***VIRGINIA DEPARTMENT OF ENVIRONMENTAL QUALITY***

Re: Mountain Valley Pipeline, LLC (MVP)  
Erosion & Sediment Control (ESC) Plan Modification (2) Approvals

The Department of Environmental Quality (DEQ) hereby approves the following modifications to the Erosion & Sediment Control (ESC) Plan:

- MLV-23 and MVP-MLV-AR-23, Sheets 12.07ES and 12.08ES, Sign/Seal dated 8/14/2023, Sheet 12.08PC, Sign/Seal dated 12/7/2022.
- MLV29, H602/H-603 Tap Sites, Details 33.1-33.4, Sheet 14.34ES, Sign/Seal dated 3/30/2022, Sheets 15.78 ES, 15.91ES, Sign/Seal dated 5/5/2022 Sheets 15.92ES, 15.93ES, 14.34AES, Sign/Seal dated 8/14/2023.

DRAWN BY:	JUZ
CHECKED BY:	RE
APPROVED BY:	TD
DATE:	12/07/2022
SCALE:	AS SHOWN
SHT. NO. 12.07PC OF 12.33PC

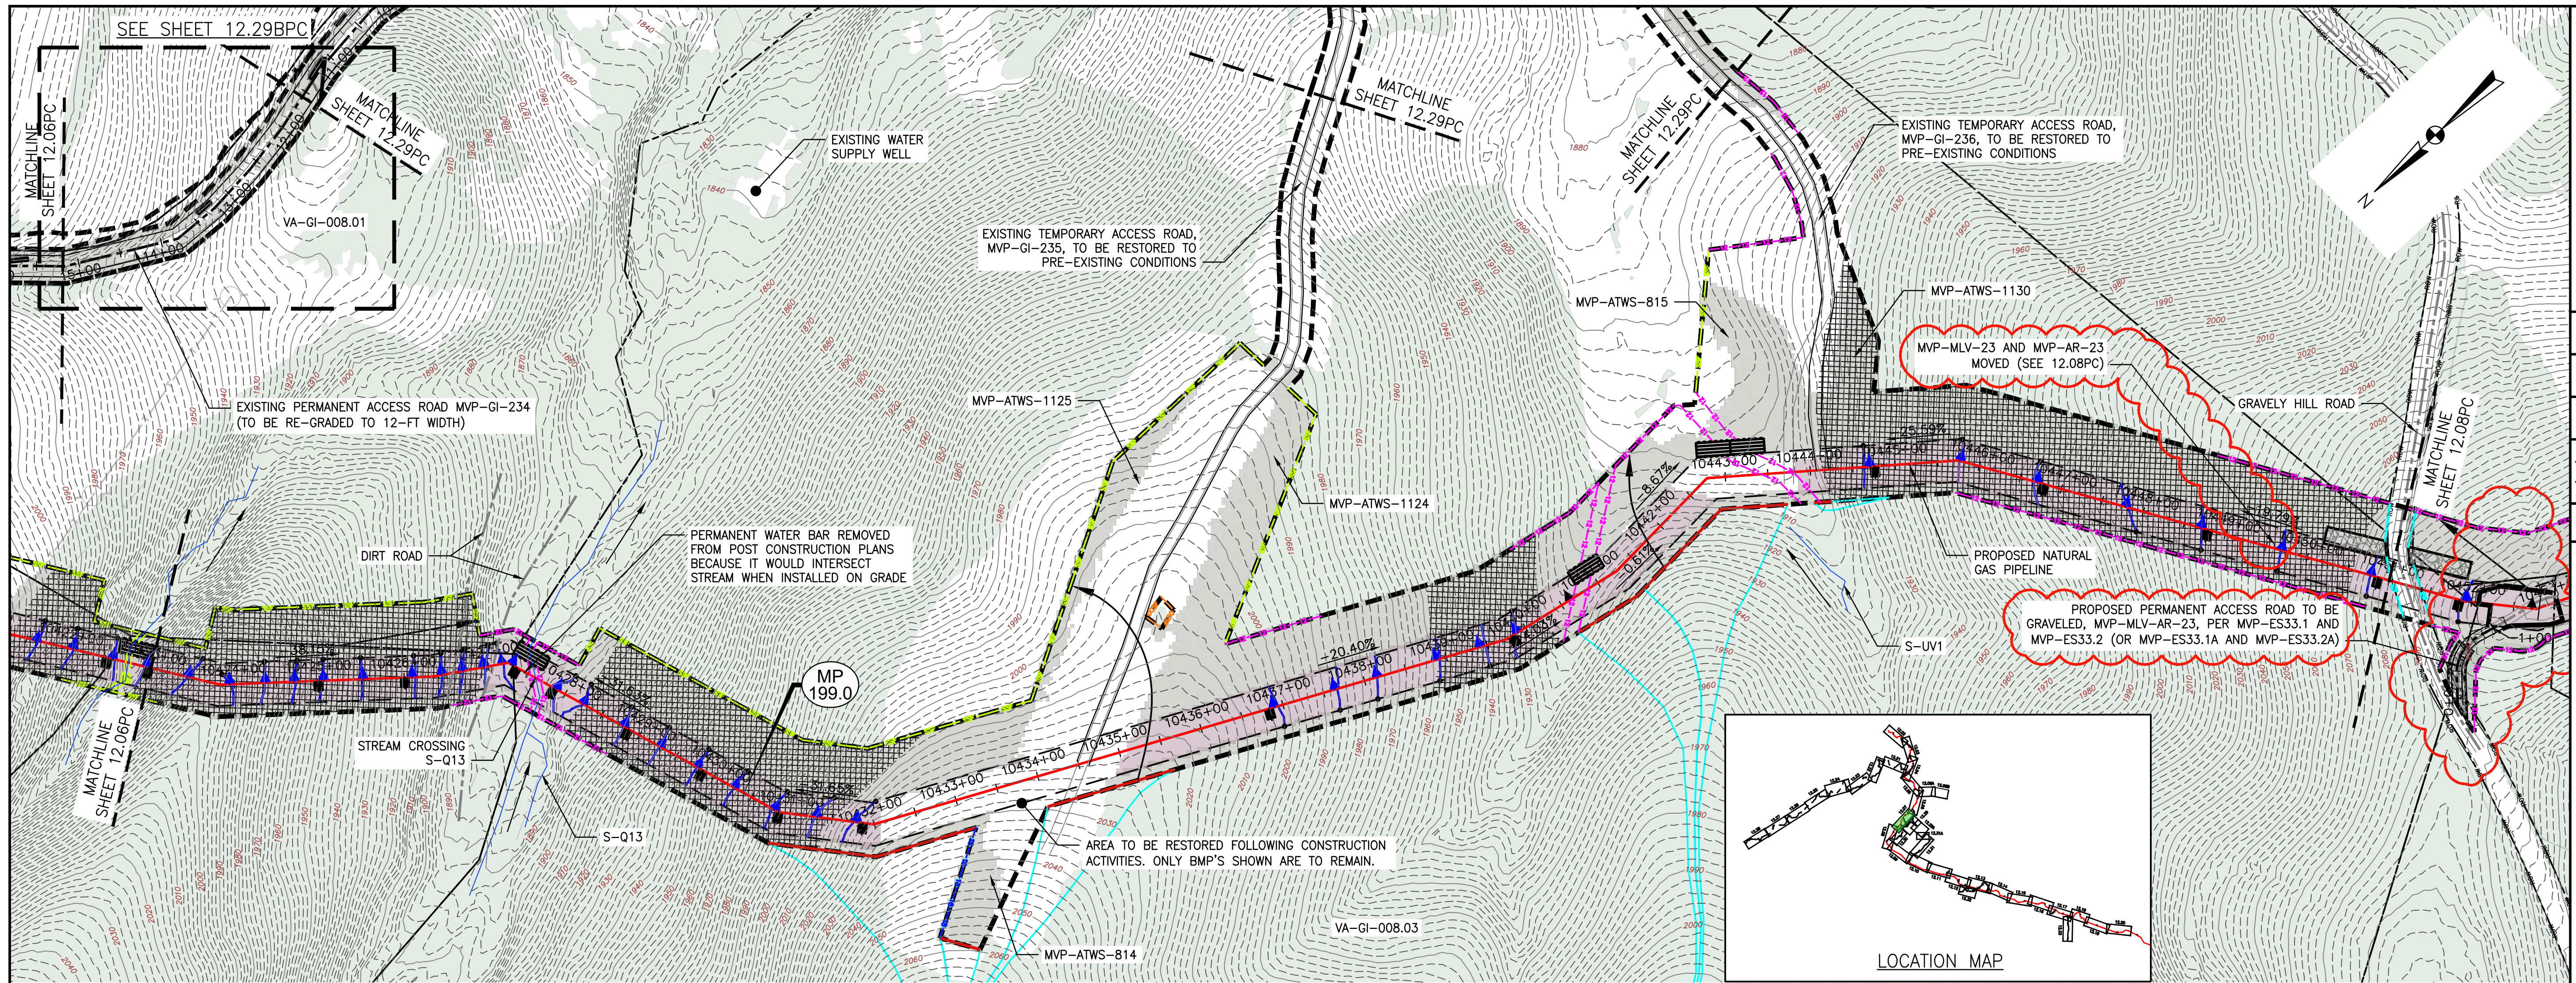
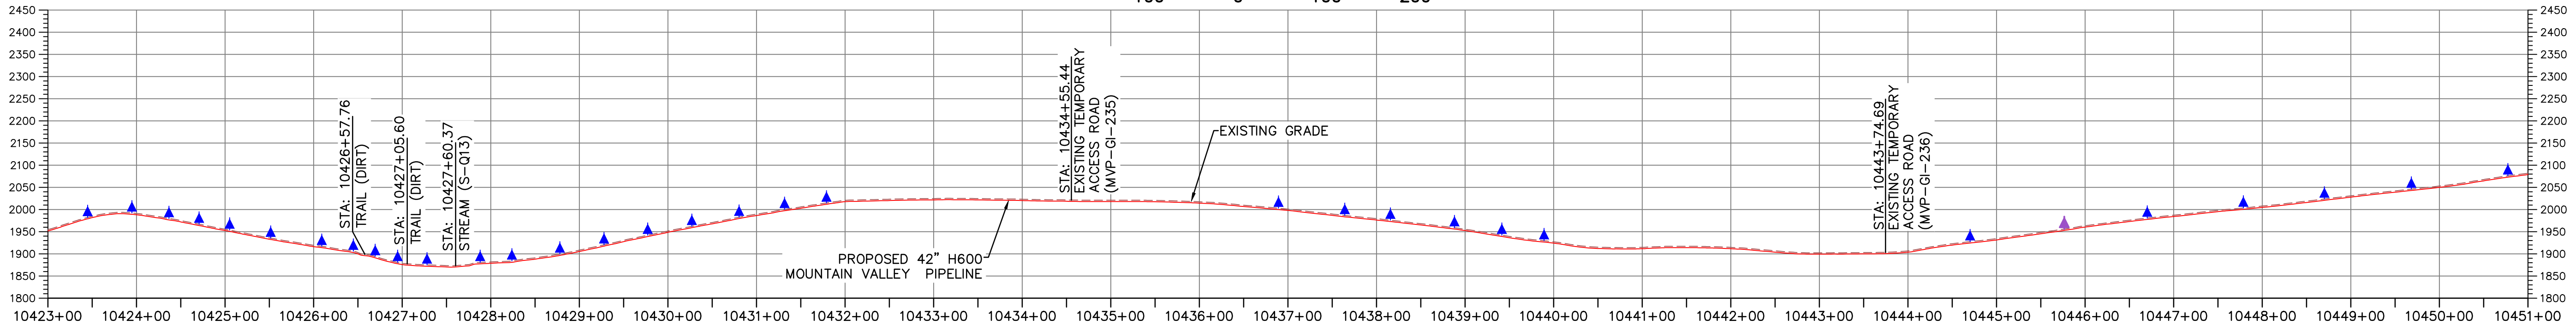
NO.	DATE	CHKD.	APPD.	DESCRIPTION
1	12/07/22			UPDATE BAFFLE SPACING FOR RELOCATION OF MLV-23
2	01/29/19			FIELD MODIFICATION - MP 199.0 (MVP-25 SITE AND ACCESS ROAD MVP-MLV-AR-23)
3	03/21/18			ADDRESS VABEC COMMENTS
4	03/16/18			ADDRESS VABEC COMMENTS
5	02/16/18			RESUBMISSION USING APPROVED STORMWATER METHODOLOGY
6	02/16/18			RESUBMISSION USING APPROVED STORMWATER METHODOLOGY
7	02/05/18			RESUBMISSION USING APPROVED STORMWATER METHODOLOGY

DATE: 12/07/2022  
 SCALE: AS SHOWN  
 SHEET NO. 12.08PC OF 12.33PC

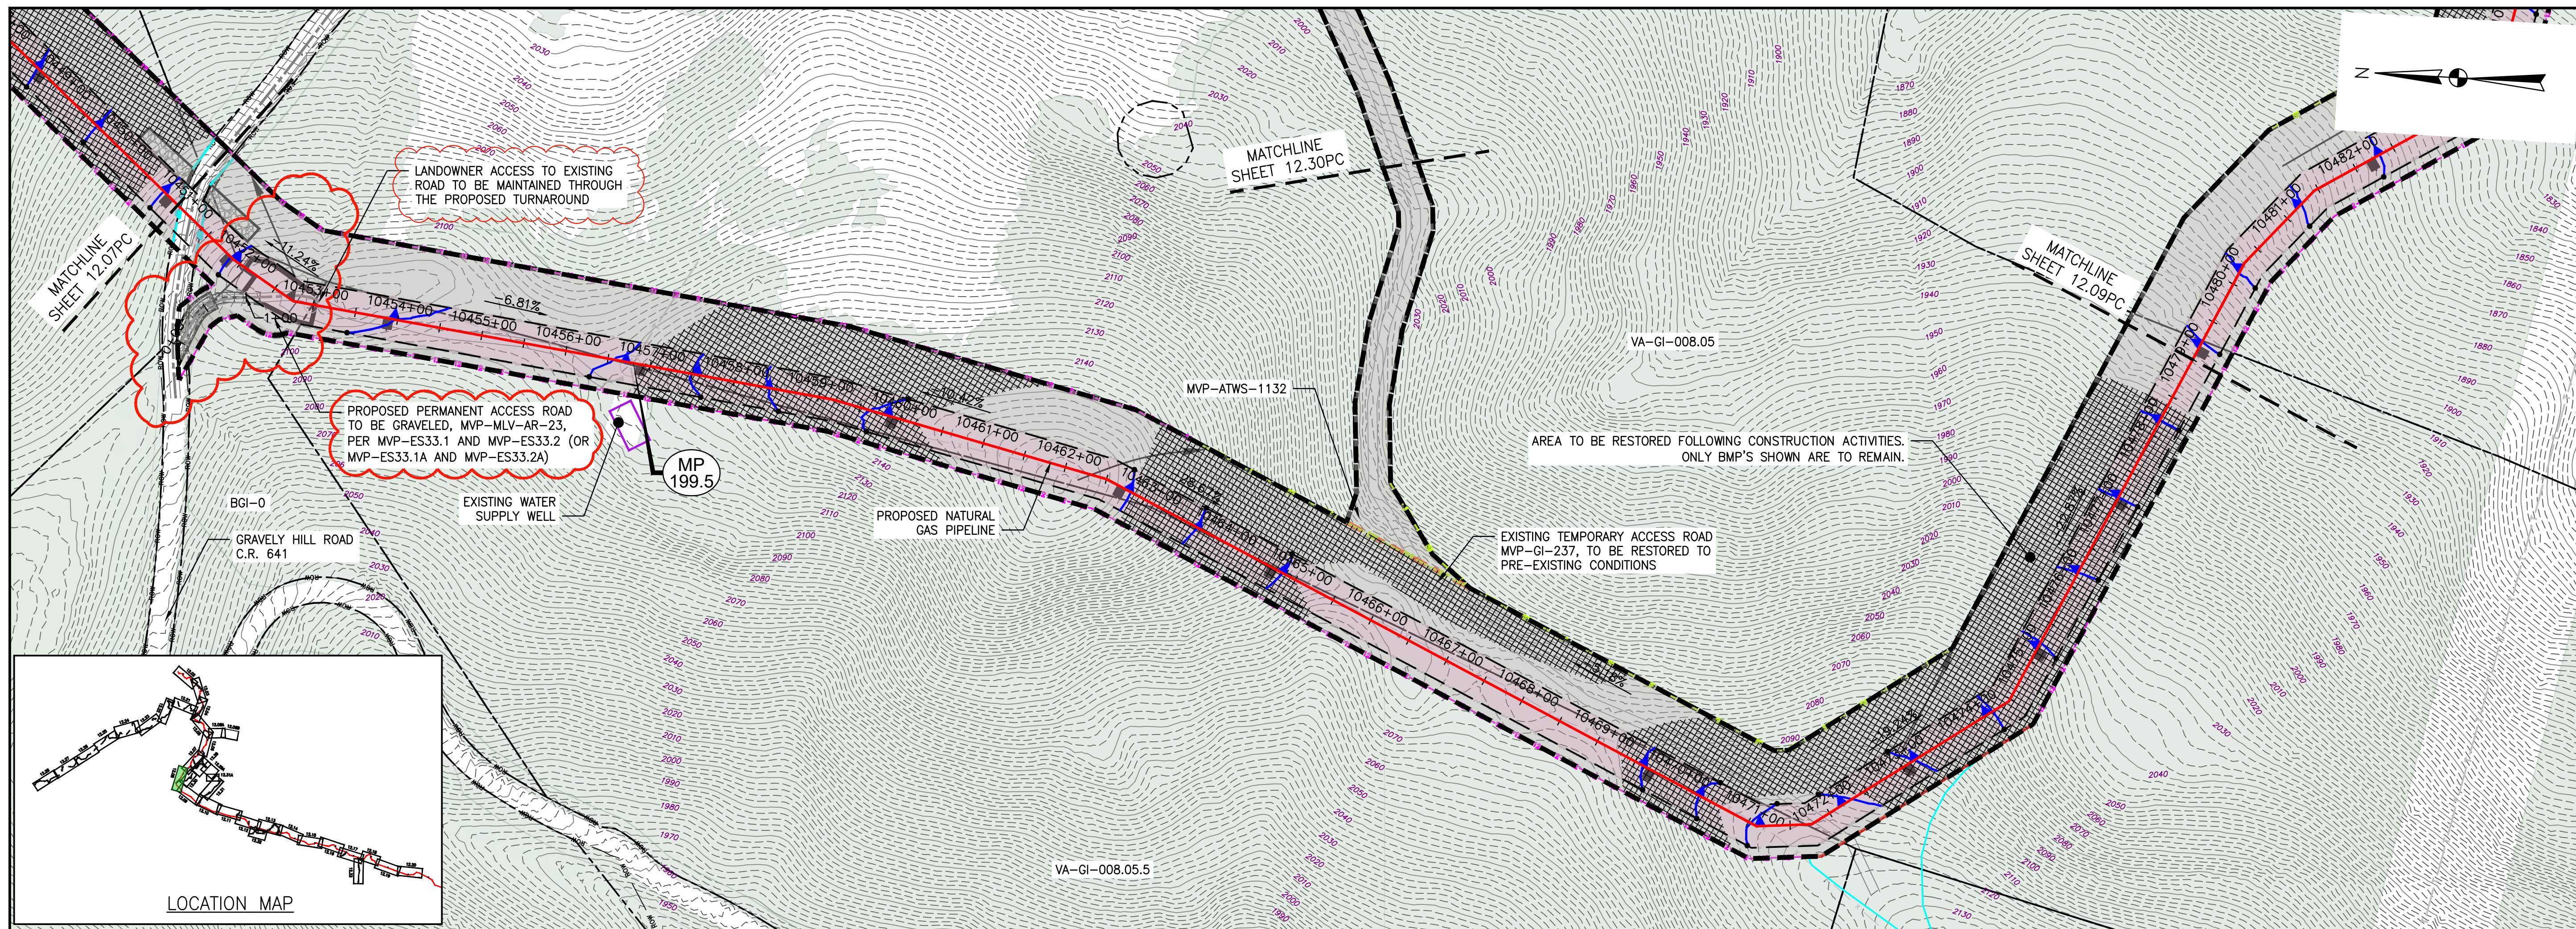
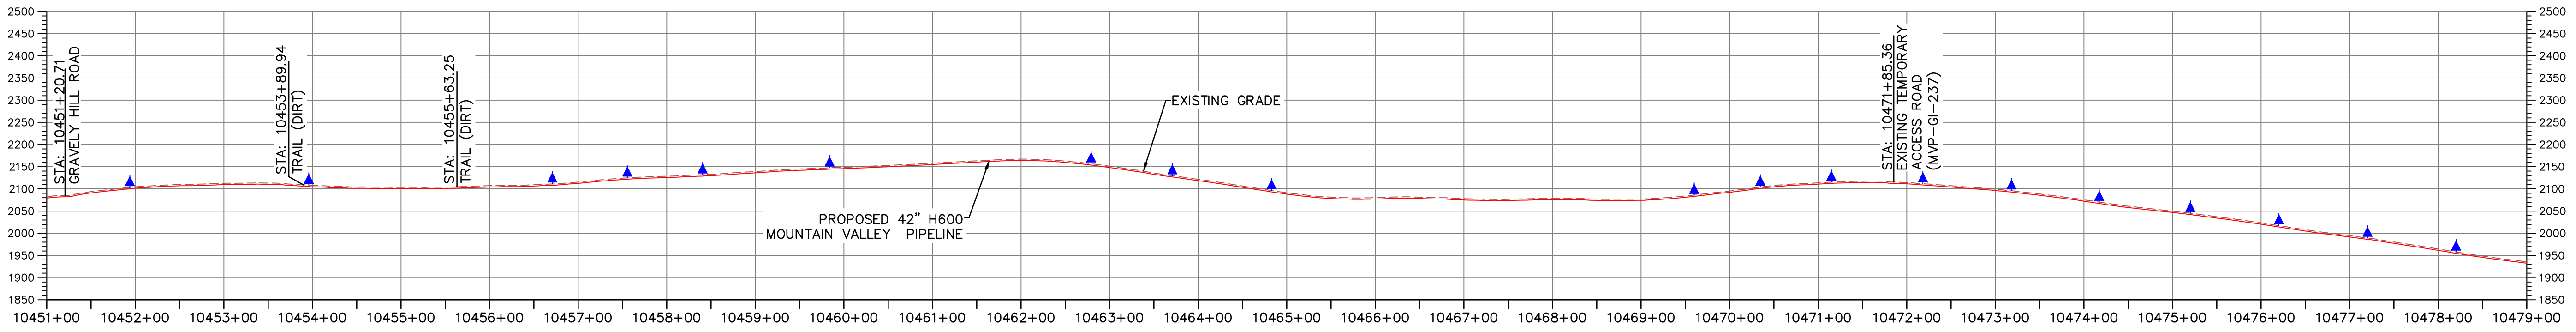
NO.	DATE	CHKD.	APPD.	DESCRIPTION
1	12/07/22			UPDATE BAFFLE SPACING FOR RELOCATION OF MLV-23
2	01/29/19			FIELD MODIFICATION - MP 199.5 SITE AND ACCESS ROAD MVP-MLV-AR-23
3	03/21/18			ADDRESS VADOC COMMENTS
4	03/16/18			ADDRESS VADOC COMMENTS
5	02/16/18			RESUBMISSION USING APPROVED STORMWATER METHODOLOGY
6	02/16/18			RESUBMISSION USING APPROVED STORMWATER METHODOLOGY
7	02/05/18			RESUBMISSION USING APPROVED STORMWATER METHODOLOGY

DRAWN BY:	JUZ
CHECKED BY:	IHH
APPROVED BY:	DCW
DATE:	07/31/2023
SCALE:	AS SHOWN
SHT. NO. 12.07ES OF 12.34ES	REVISION

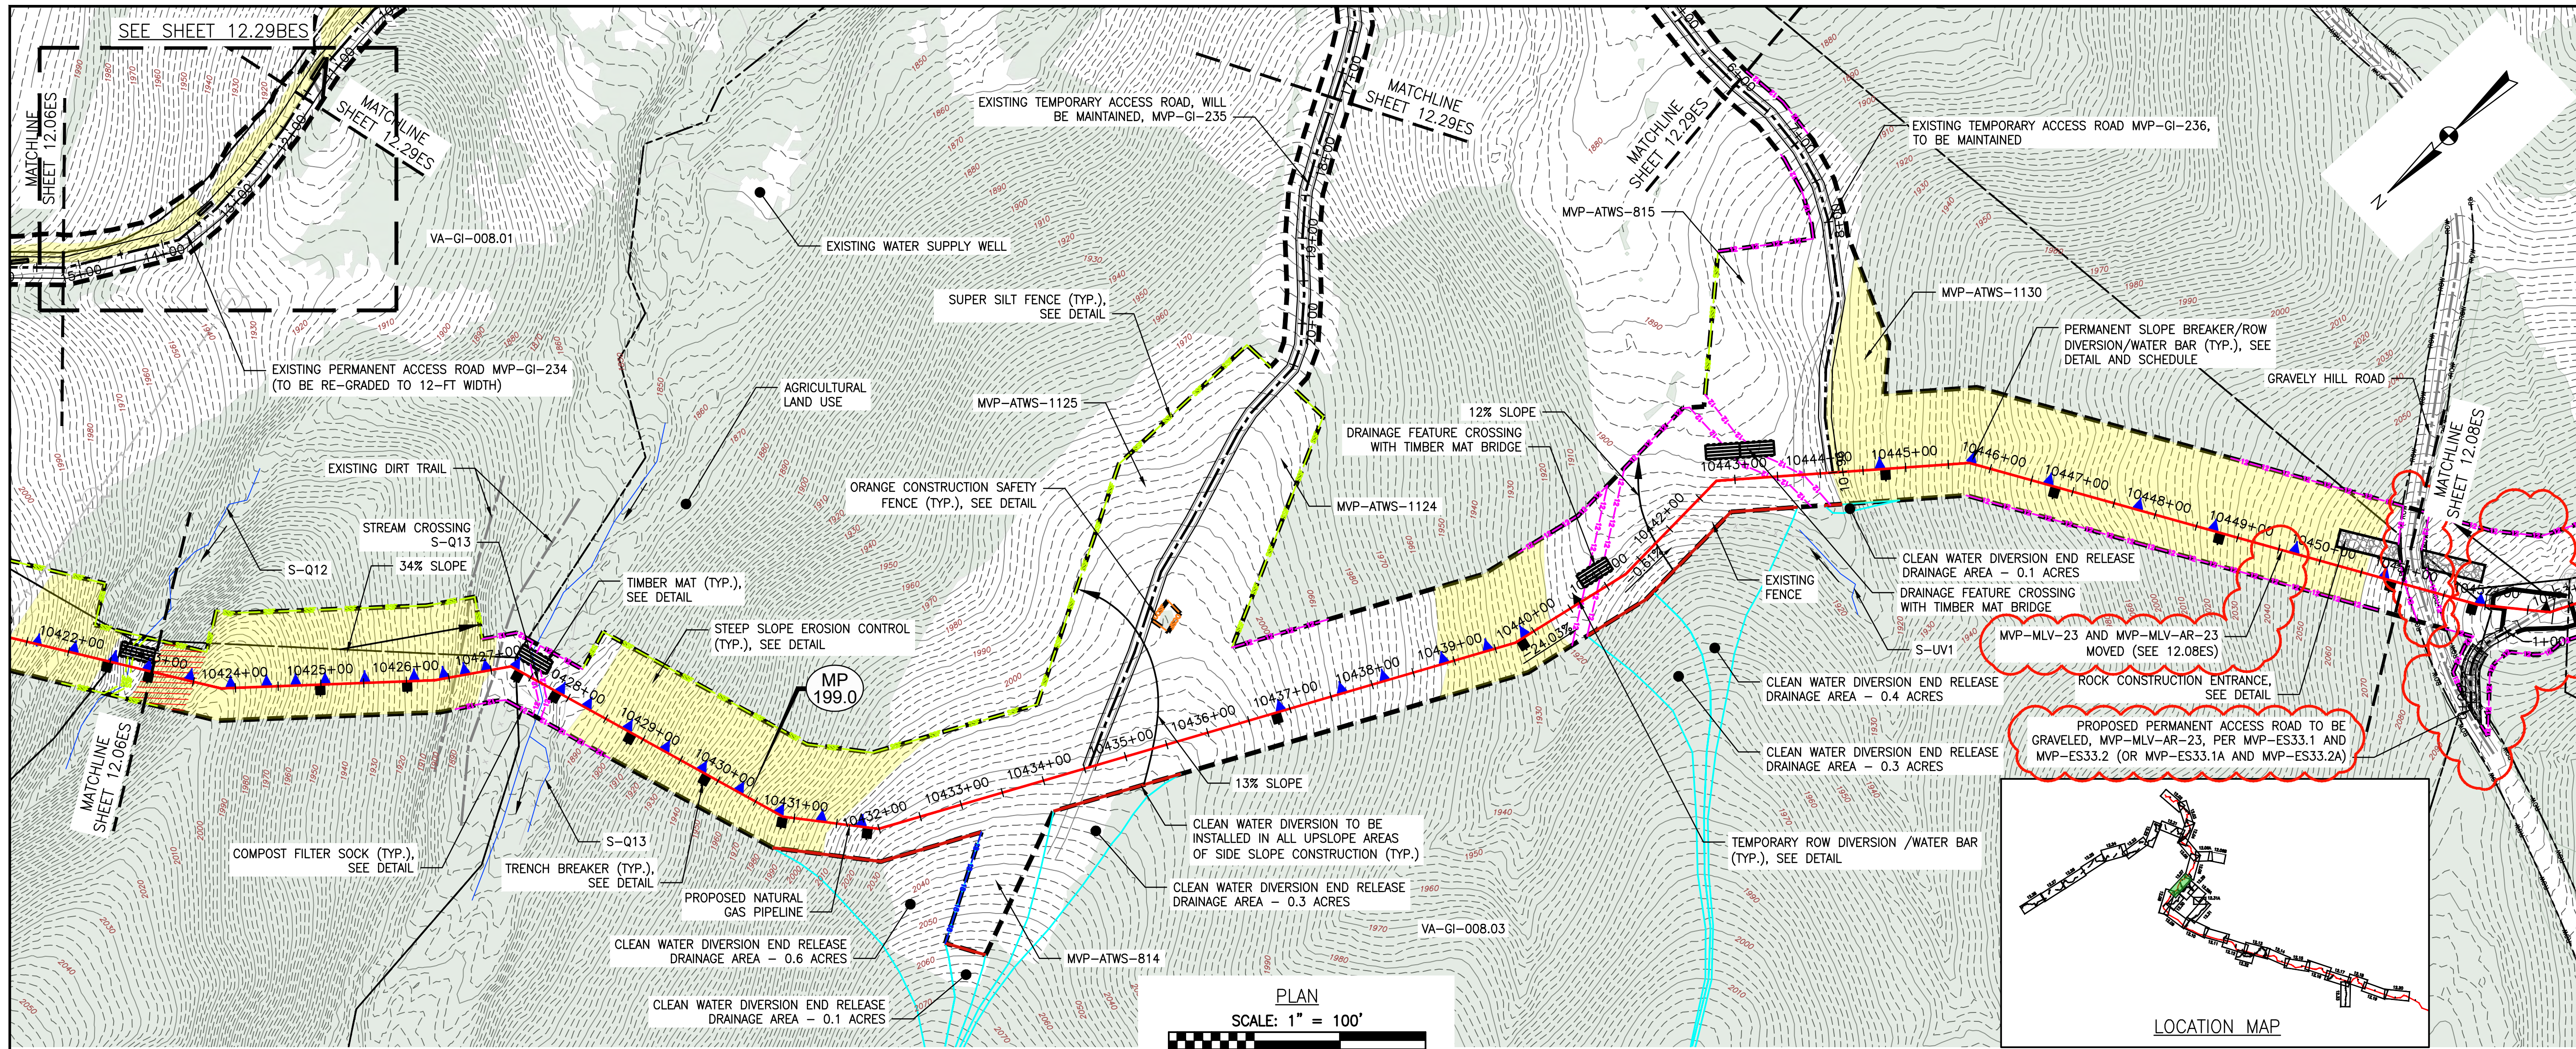
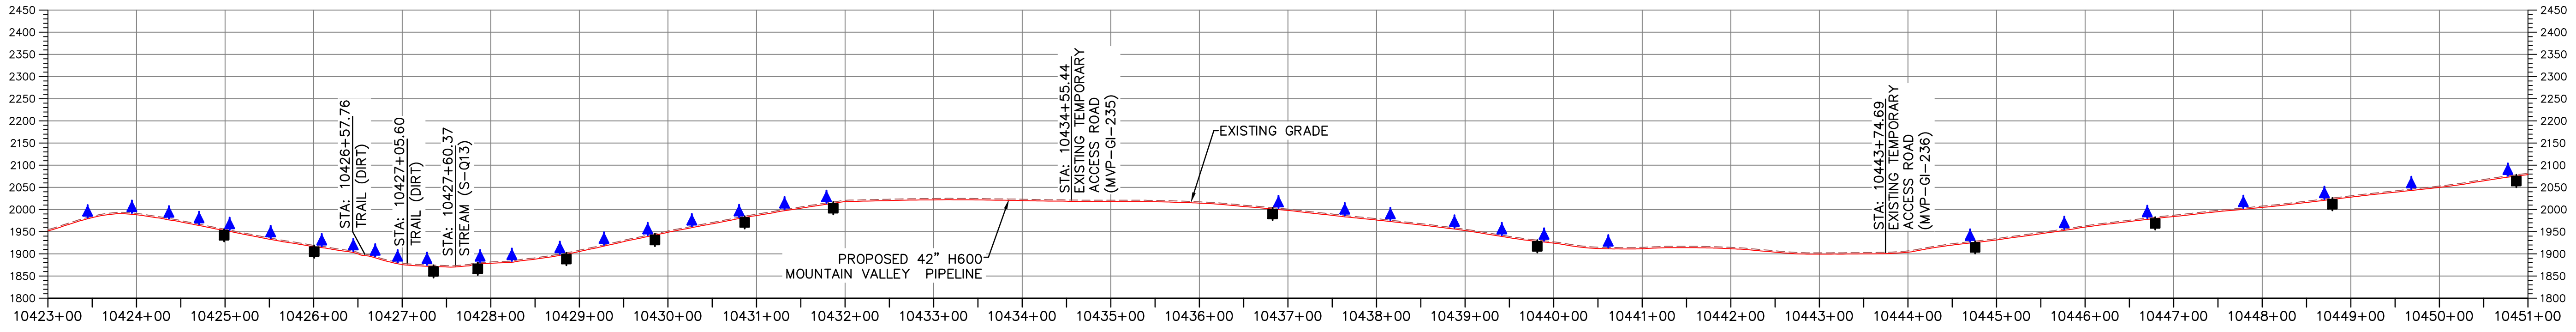
NO.	DATE	CHKD.	APPD.	DESCRIPTION
1	07/31/23	JUZ	DCW	ADDRESS VAREQ COMMENTS
2	12/07/22	MJP	RE	UPDATE BAFFLE SPACING FOR RELOCATION OF MLV-23
3	01/29/19	JWK	RE	ADD MODIFICATION - HP 1965 (MVP-23 SITE AND ACCESS ROAD MVP-AR-23)
4	03/16/18	KAL	RE	ADDRESS VAREQ COMMENTS
5	02/26/18	KAL	RE	ADDRESS VAREQ COMMENTS
6	02/22/18	KAL	RE	ADDRESS VAREQ COMMENTS
